**BEAMREACH NETWORKS, INC.
BELL SOUTH CORPORATION
VERIZON WIRELESS, INC.
WORLD COM, INC.**

*Re: Establishment of Rules and Policies for the Satellite
Digital Audio Radio Service in the 2310-2360 MHz Band;
IB Docket No. 95-91*

Response to XM Radio's Supplement to August 29, 2001 White Paper¹

Figure 12

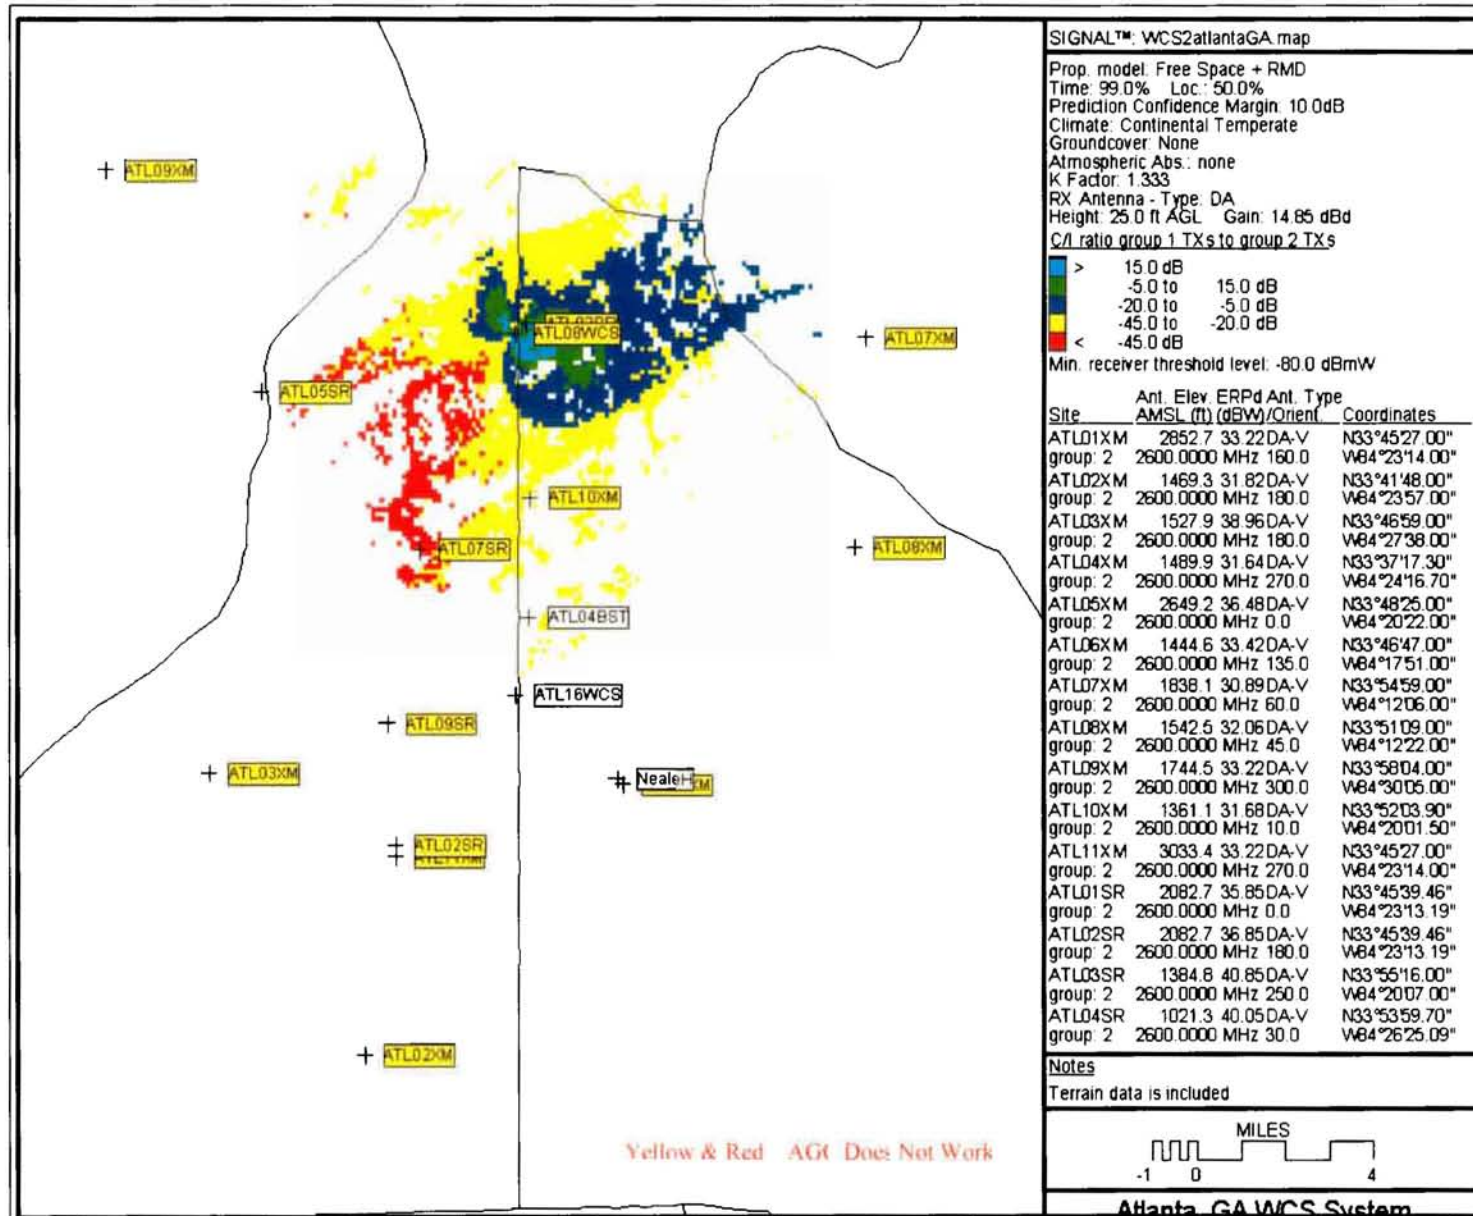
In Figure 12 all fourteen SDARS transmitters are turned on. These SDARS EIRP levels are the levels stated in the SDARS licensees' STA applications. This simulation again looks at the RF coverage area of WCS base station ATL08WCS. The WCS CPE in the WCS cell coverage area is equipped with RF front-end AGC. The WCS cell coverage at these SDARS EIRPs is shown by the colors blue, green and bluish green. These colors represent receive levels with a power gap of 20 dB or less.

Because of the inability of the AGC to mitigate the interference, the WCS cell radius has been severely reduced with a *loss in area covered of 53%*.

Figure 13
RF Coverage from WCS Base Station at 2W

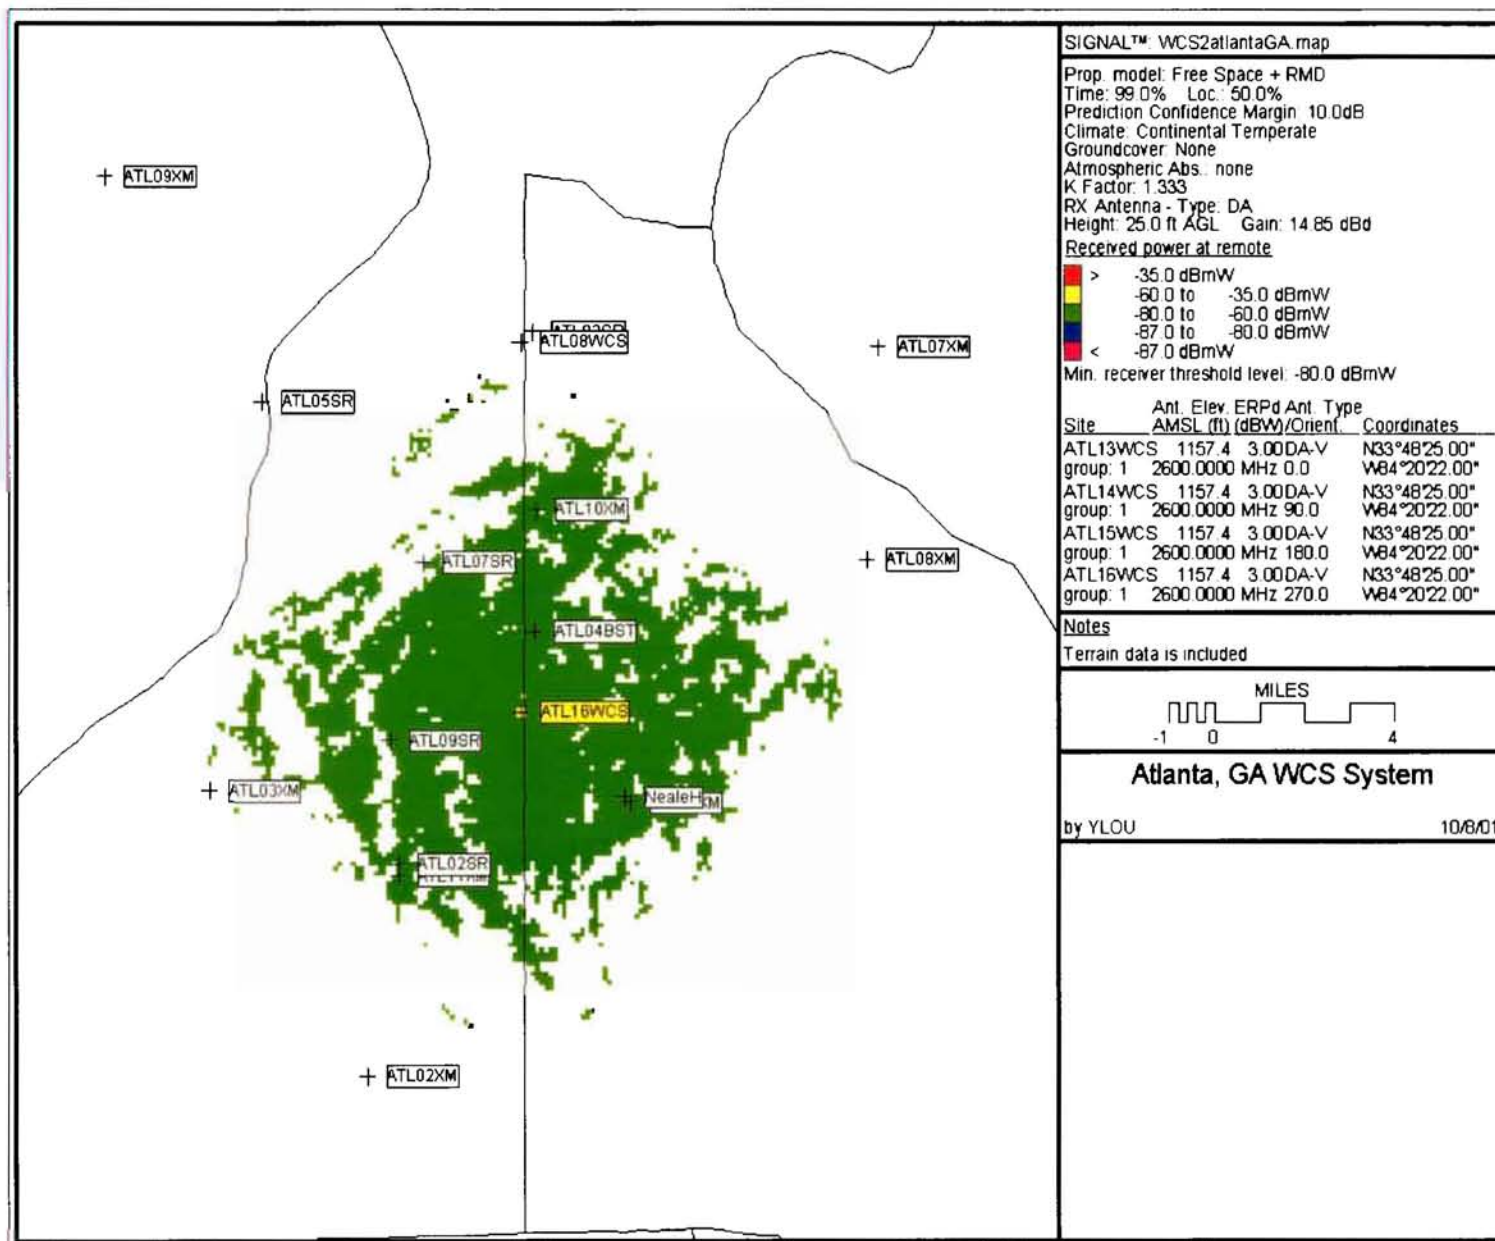
Figure 13 shows the RF coverage area of WCS base station ATL16WCS that is collocated with a nontransmitting SDARS base station. The usable RF coverage includes the areas shown by the colors green and yellow. RF coverage varies from 5 to 6 miles.

Figure 14
SDARS (at 40KW) Interference to WCS System

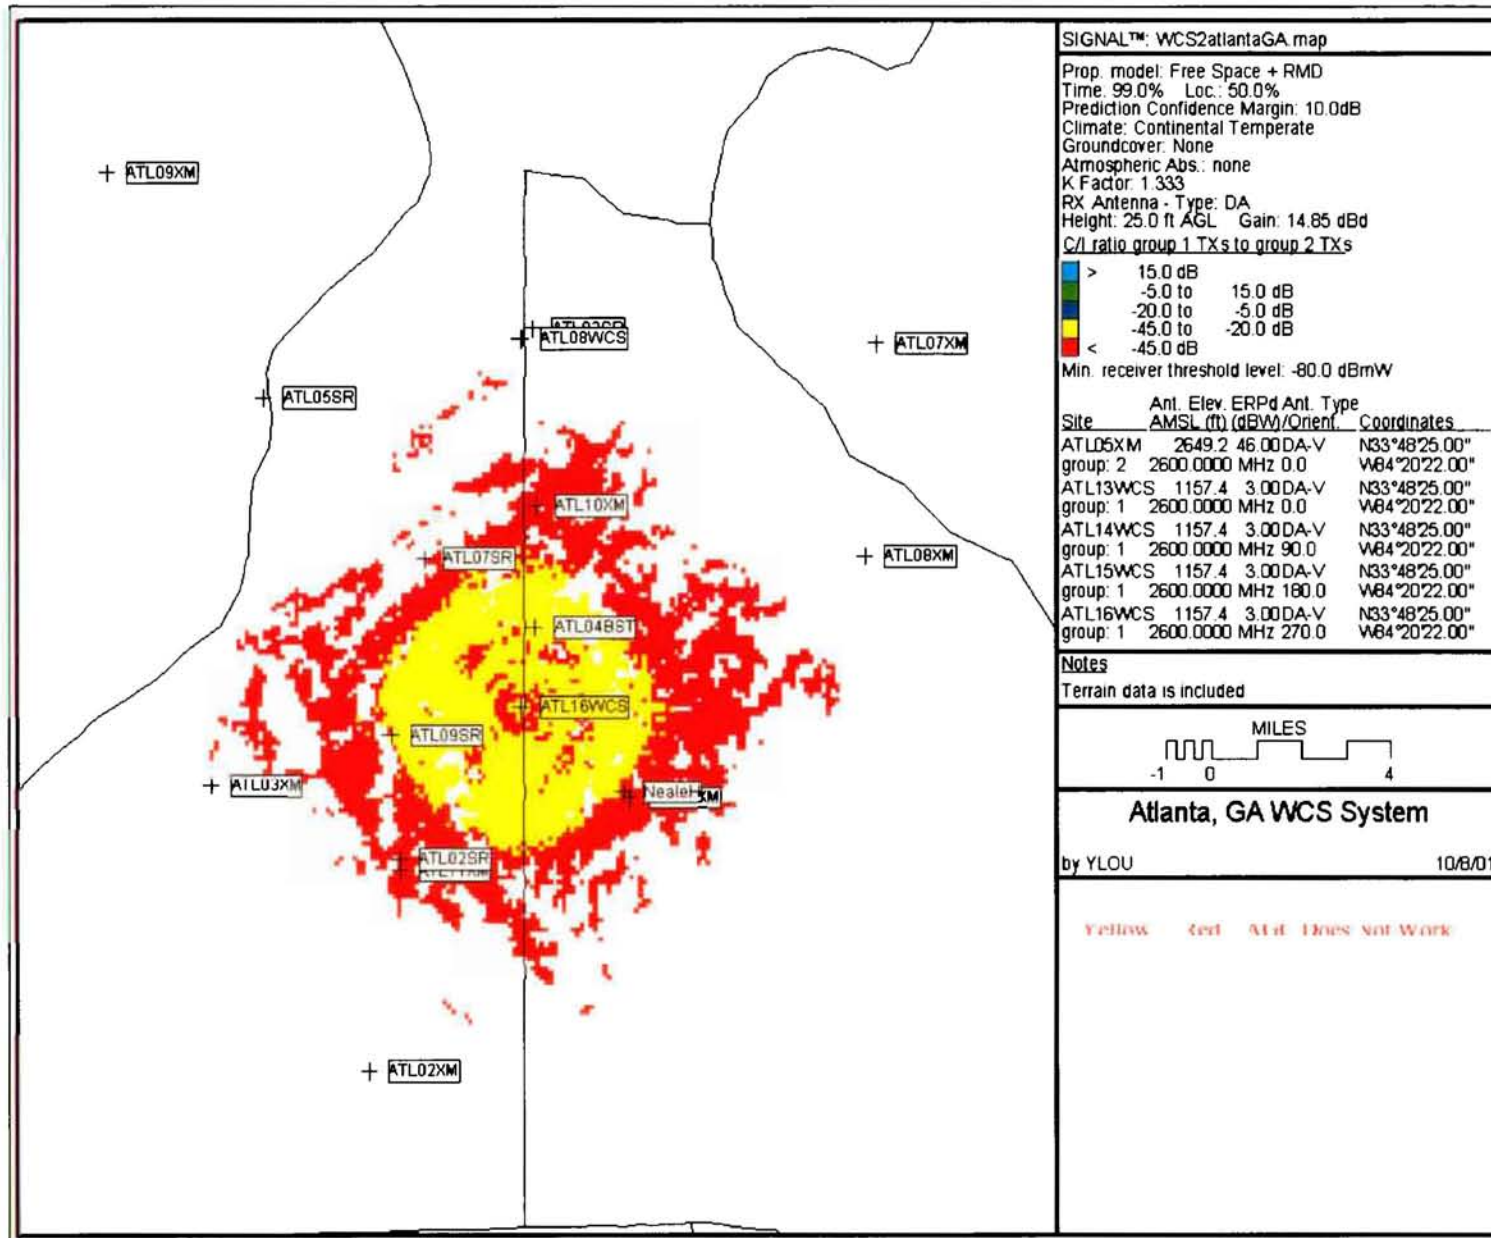
In Figure 14 the SDARS transmitter that is collocated with WCS base station ATL16WCS is turned on with an EIRP of 40 kW. This simulation again looks at the RF coverage area of WCS base station ATL16WCS. The WCS CPE in the WCS cell coverage area is equipped with RF front-end AGC. The new WCS cell coverage is shown by the colors blue, green and bluish green. These colors represent receive levels with a power gap of 20 dB or less.

- The areas colored by yellow and red are the areas where AGC does not work for intermodulation interference.
- There is no area in the cell where the AGC solution works for intermodulation interference. The area colored in red is the area where AGC does not work for overload interference.

Because of the inability of the AGC to mitigate the interference, the WCS cell radius has been reduced to zero miles with *a loss in area covered of 100%*.

Figure 15
SDARS Repeater at 7.3KW (Original Design) Interference to WCS System

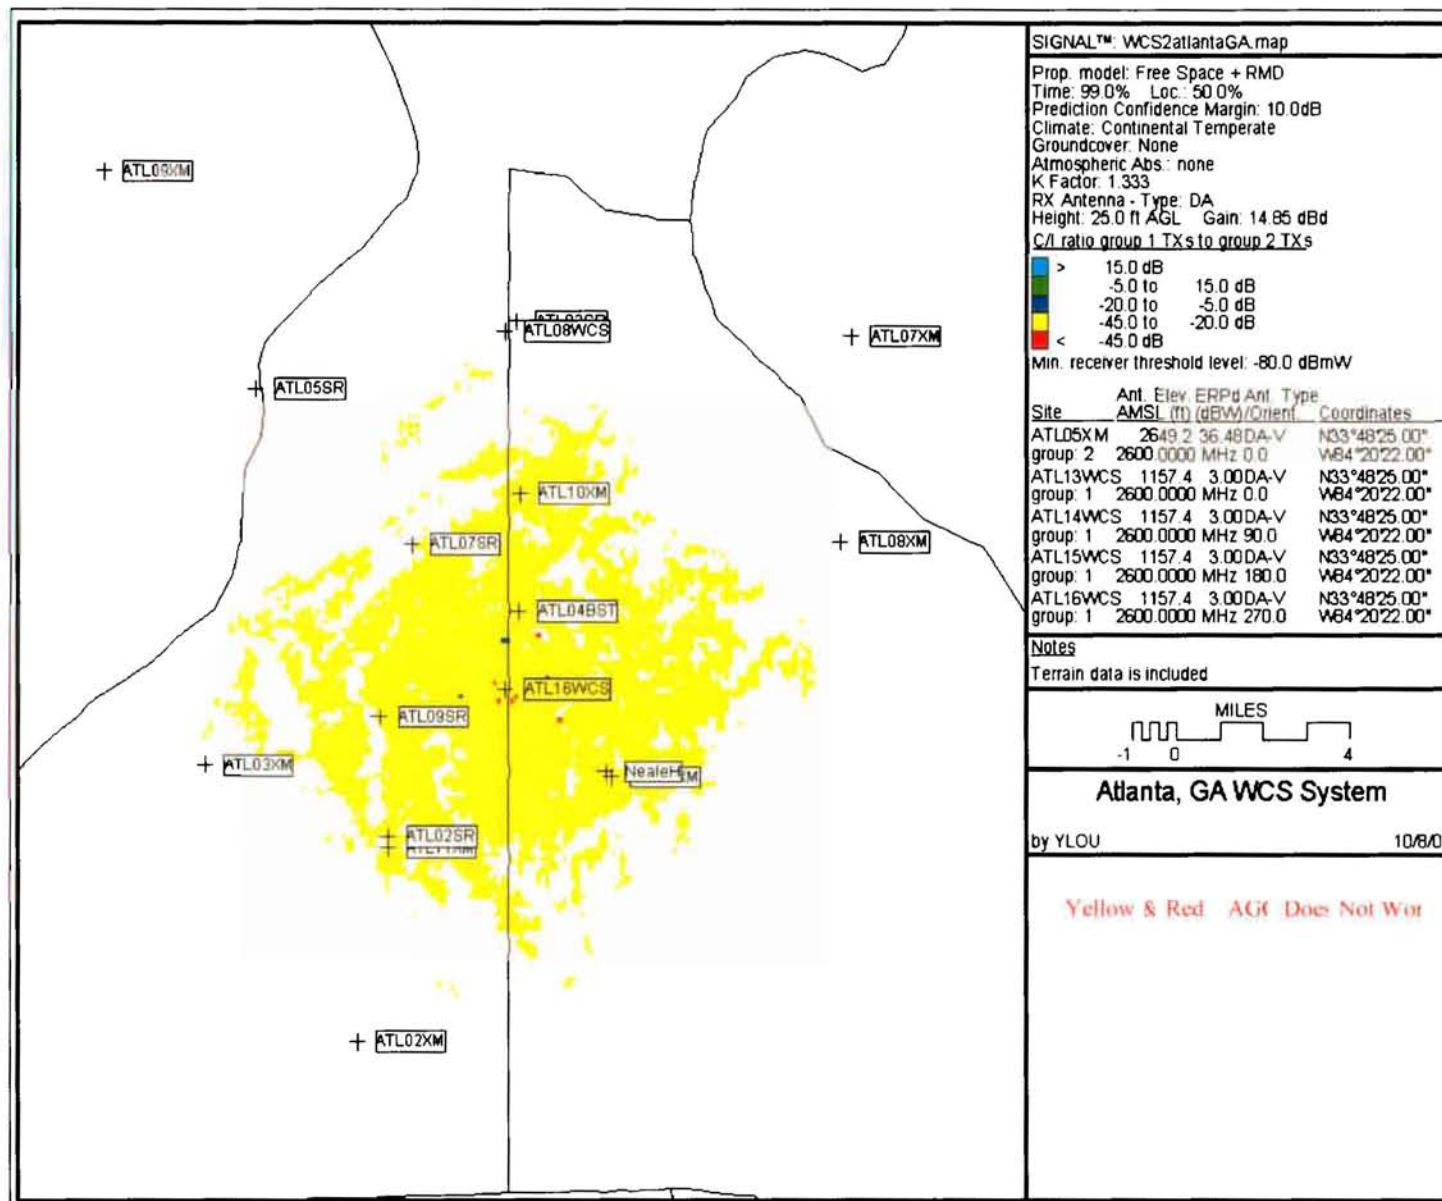
In Figure 15 the SDARS transmitter that is collocated with WCS base station ATL16WCS is turned on with an EIRP of 7.3 kW. This SDARS EIRP is the level stated in the SDARS STA application. This simulation again looks at the RF coverage area of WCS base station ATL16WCS. The WCS CPE in the WCS cell coverage area is equipped with RF front-end AGC. The WCS cell coverage at this SDARS EIRP is shown by the colors blue, green and bluish green. These colors represent receive levels with a power gap of 20 dB or less. The areas colored by yellow and red are the areas where AGC does not work for intermodulation interference. The area colored in red is the area where AGC does not work for overload interference. There is essentially no area in the cell where the AGC solution works for intermodulation interference. Because of the inability of the AGC to mitigate the interference, the WCS cell radius has been reduced to zero miles with *a loss in area covered of 100%*.

Figure 16
SDARS Repeater at 2KW Interference to WCS System

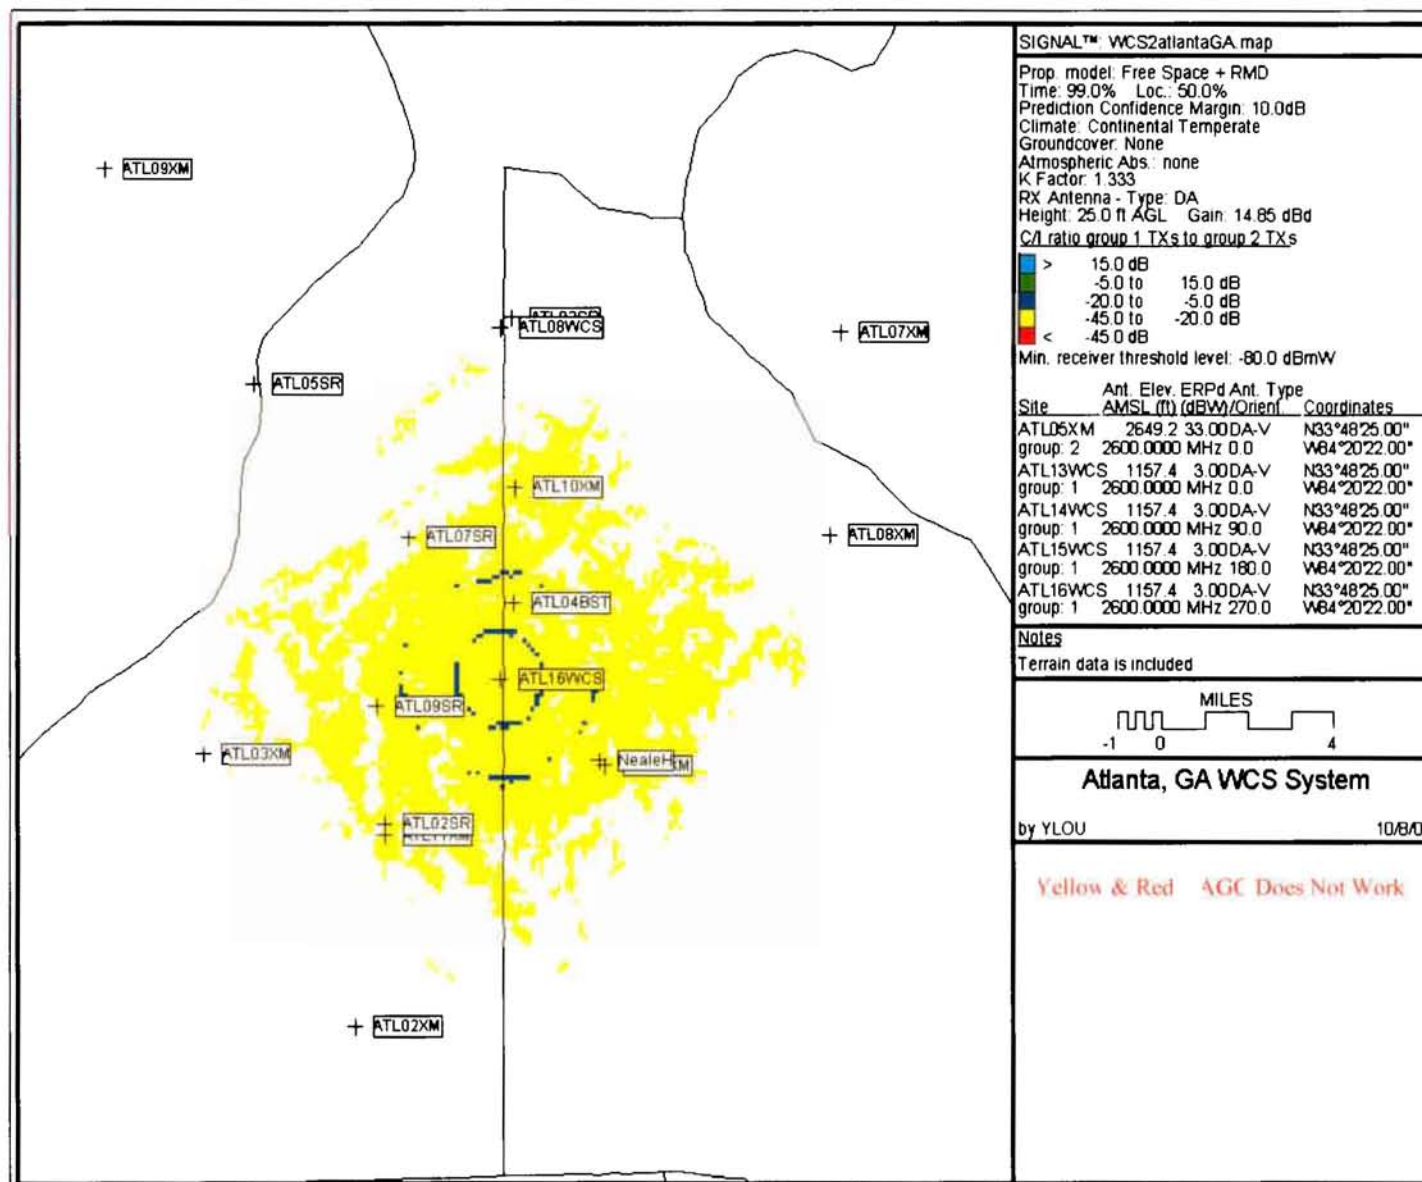
In Figure 16 the SDARS transmitter that is collocated with WCS base station ATL16WCS is turned on with an EIRP of 2 kW. This simulation again looks at the RF coverage area of WCS base station ATL16WCS. The WCS CPE in the WCS cell coverage area is equipped with RF front-end AGC. The WCS cell coverage at this SDARS EIRP is shown by the colors blue, green and bluish green. These colors represent receive levels with a power gap of 20 dB or less.

- The areas colored by yellow and red are the areas where AGC does not work for intermodulation interference.
- The area colored in red is the area where AGC does not work for overload interference. There are very few areas in the cell where the AGC solution works.

Because of the inability of the AGC to mitigate the interference, the WCS cell radius has been essentially reduced to zero with *a loss in area covered of 98%*.
